Access Compliance Report

Public Rights-of-Way

(Pedestrian Signals)

Intersection ID: N/A	Main Street:	Cross Street: N/A	Location: N/A
ADA ID: AC3729B2C5E4	Signal Type: One Push Button-APS	Overall Compliance: No	Severity Score: BTN 1: N/A BTN 2: N/A No BTN: N/A
Codes/Mitigation Info/Possible Solution		Field Measurements/Component Compliance

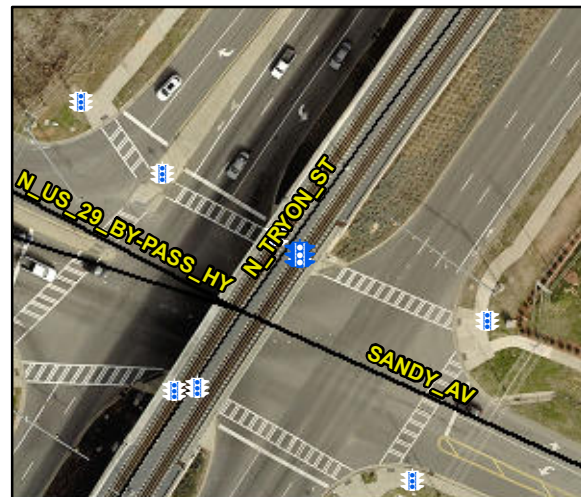
Surveyor Notes: TEXT HT 5/16

PROW/ADA: R410.6, TMUTCD 4e.08, R404.2, R404.3, R406.2, R404.7.3, R209.1, MUTCD 4e.10

Yes	B 1 Clear Xing Direction?	ClearlyMarked	N/A	B 2 Clear Xing Direction?	N/A
	B 1 Crossing Direction	To E		B 2 Crossing Direction	N/A
Yes	B 1 DistanceTo XWalk (in)	6.0	N/A	B 2 DistanceTo XWalk (in)	N/A
No	B 1 DistanceTo Curb (in)	100.0	N/A	B 2 DistanceTo Curb (in)	N/A
Yes	B 1 Diameter (in)	2.0	N/A	B 2 Diameter (in)	N/A

Possible Solutions: Replace Signal Push Button With APS Button on New Post. Remove & Replace Sign.
